# Rezoning Transportation Analysis

Petition Number: #2022-091

General Location Identifier: 15114288

## Revision Log:

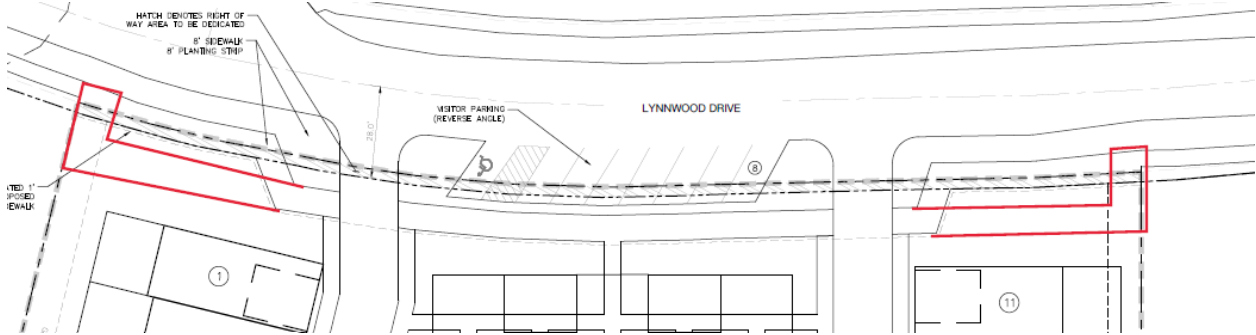
- ~~4. Revise site plan and conditional note(s) to remove angled parking and install parallel parking on Lynnwood Drive.~~

~~**Comment Clarification 01-27-23:** CDOT is comfortable with the reverse angled parking given context of the existing street network and neighborhood development. Add conditional note stating that appropriate signage for reverse angle parking will be coordinated with CDOT during permitting.~~
